Our Ref: 11659/2.7
Your Ref: R/53/22/DOC

Rustington Convalescent Home, Sea Road, Rustington, BN16 2LZ

We refer to Southern Water's consultation response letter dated 29th March 2022 and refusal to discharge Condition 19 relating to foul disposal.

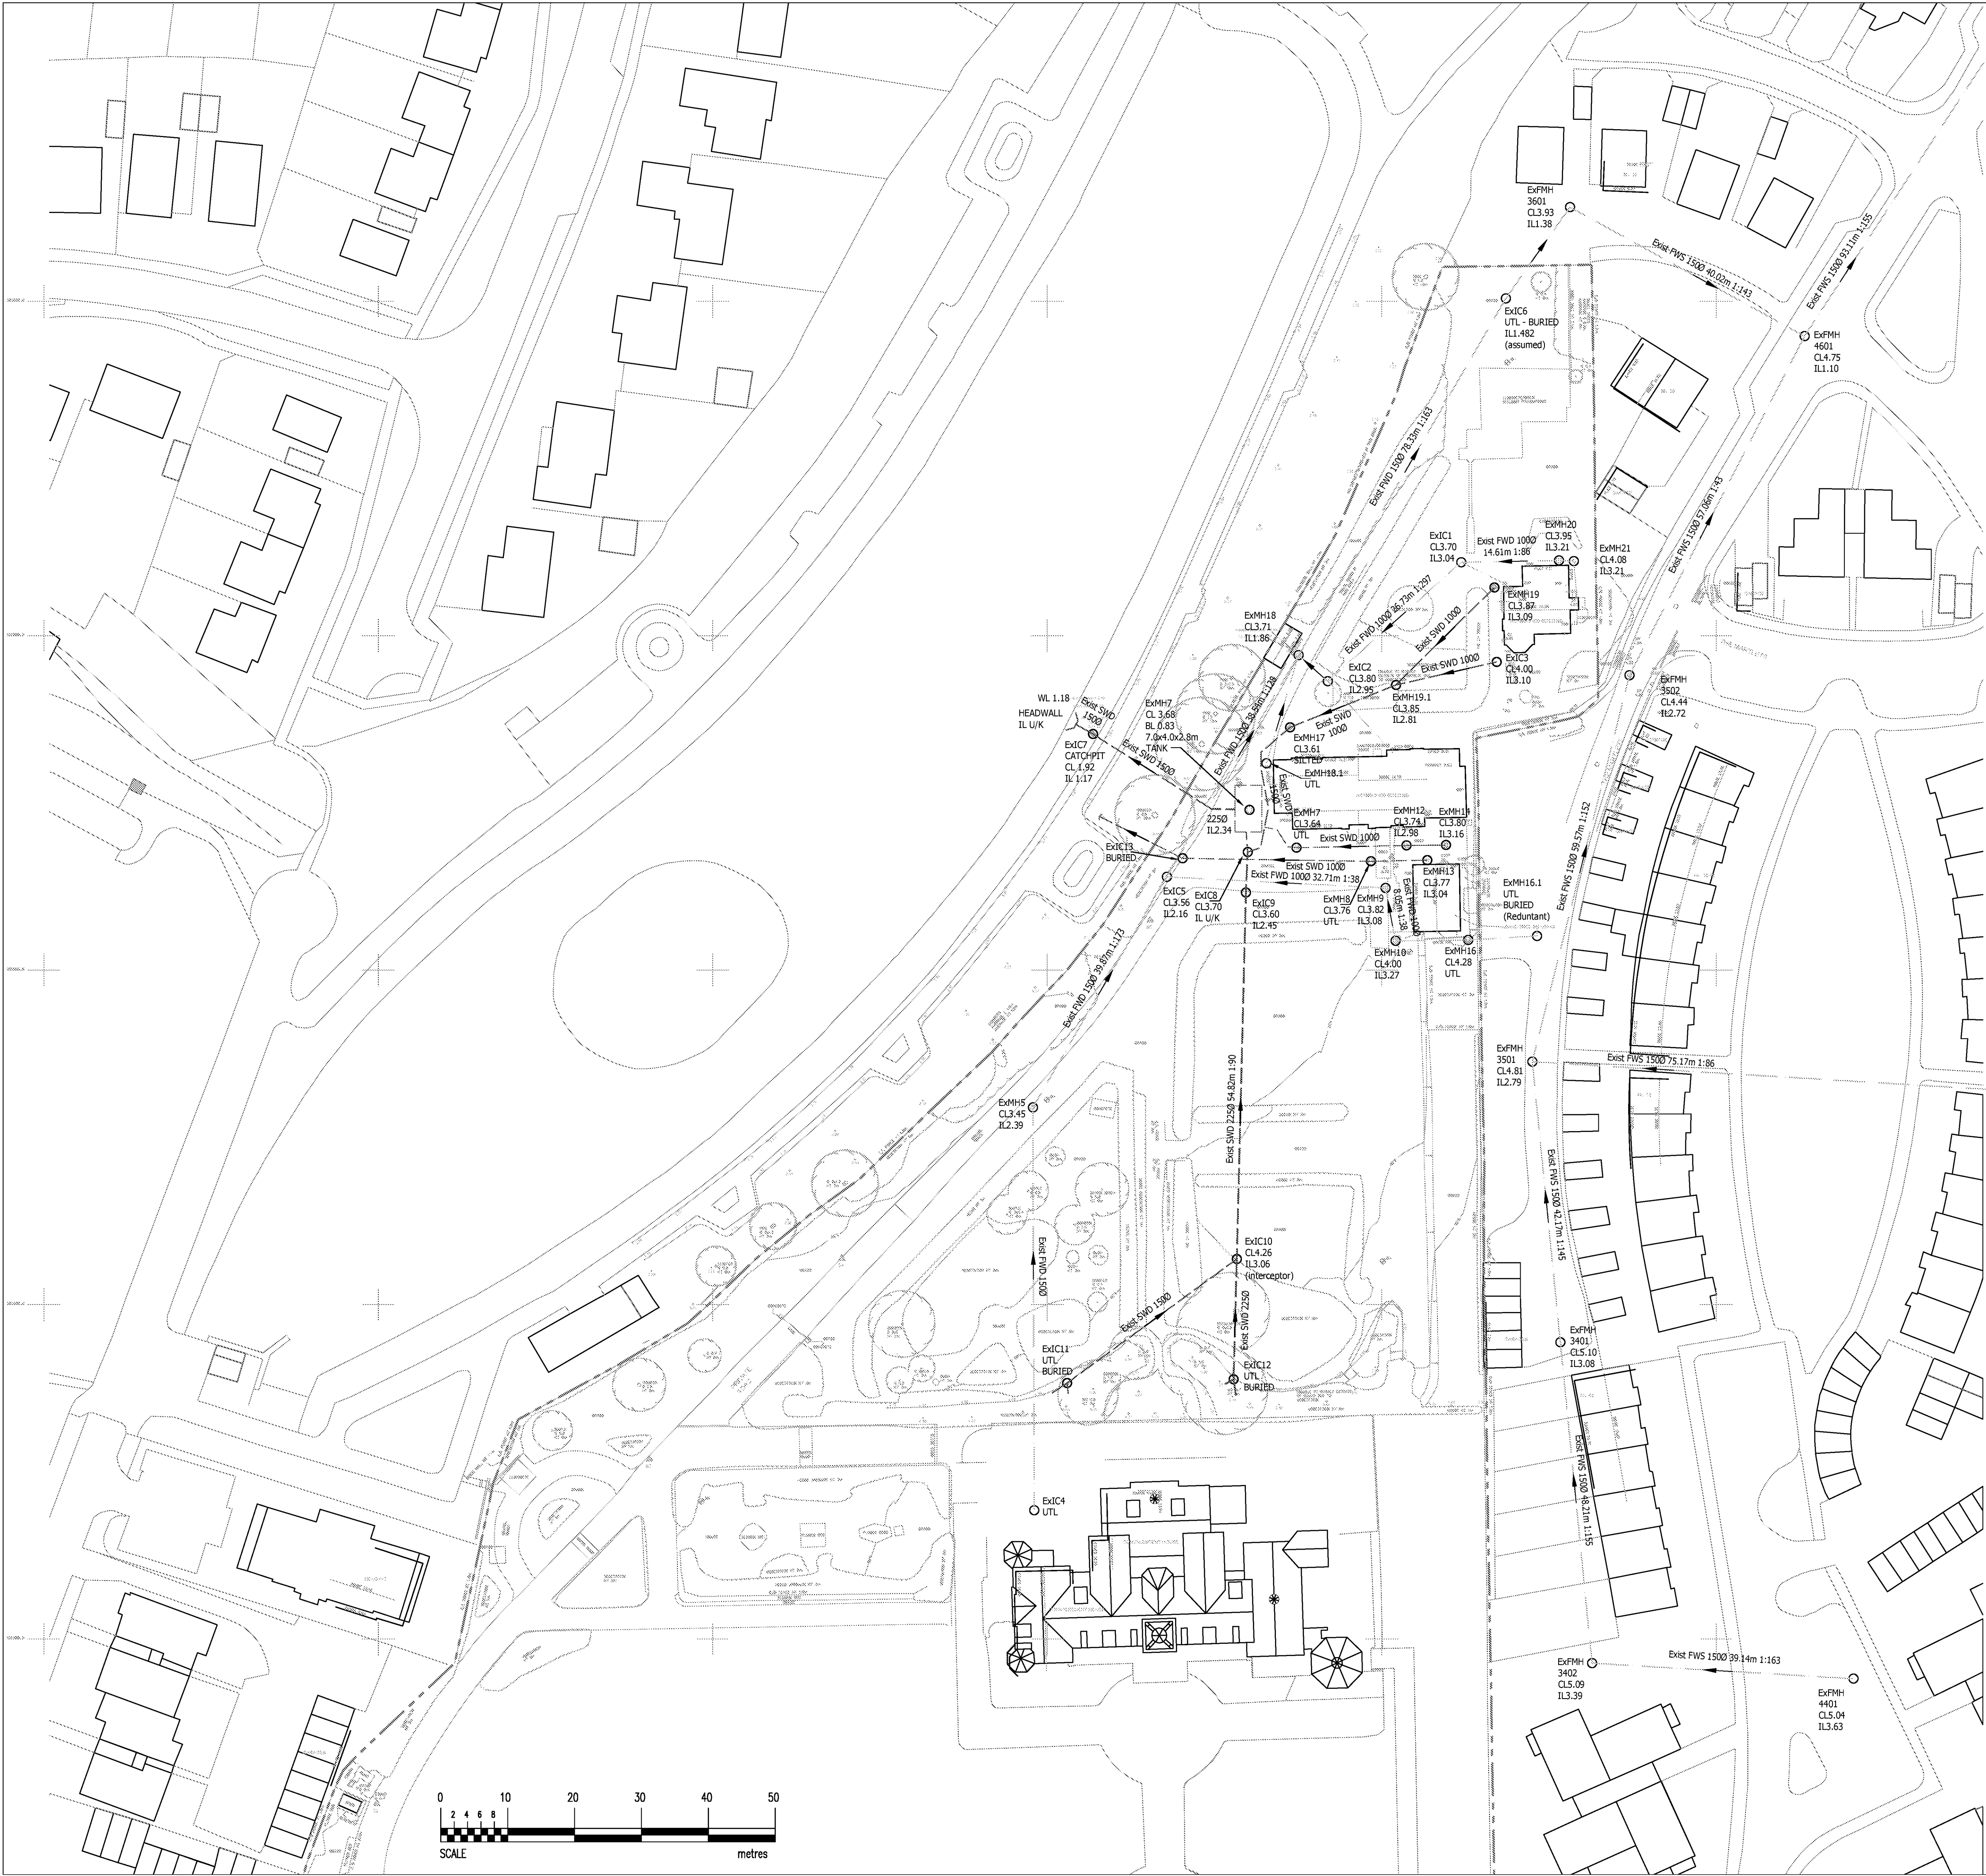
Please find enclosed our drawing 11659/1003/P3. This drawing has been prepared using detailed information derived from extensive CCTV survey in December 2021 and shows that all the drainage, both foul and surface water, is contained within and serves only the site defined by the red site ownership boundary line, except for the final drainage pipes linking to offsite drainage. Only these outfall pipes are to be retained to serve the development. The existing on-site drainage is not suitable for retention to serve the development due to its layout.
